WEST BURTON SOLAR – DEADLINE 3 –JANUARY 9<sup>TH</sup> 2024

ExQ1 – 15 DECEMBER 2023

## West Burton Solar Project

### Environmental Statement Chapter 10: Hydrology, Flood Risk and Drainage

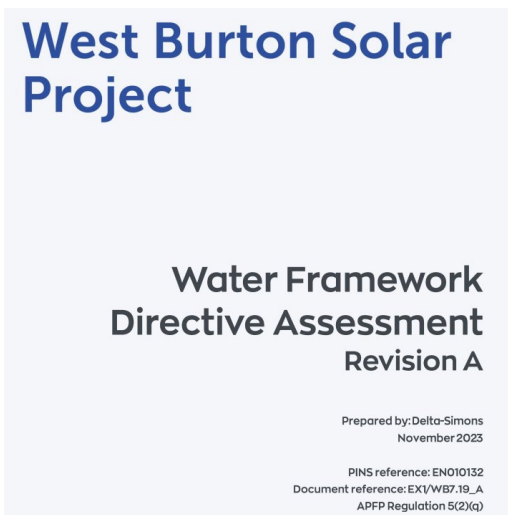
Drainage ditches in the 30 affected communities, as we have seen again in recent months, have been unable to cope with excessive volumes of water leading again to flooding of the agricultural /farmland of the proposed West Burton and Cottam Solar projects as the River Till has burst its banks. Local roads in the affected communities were also flooded and impassable. See illustration below:-
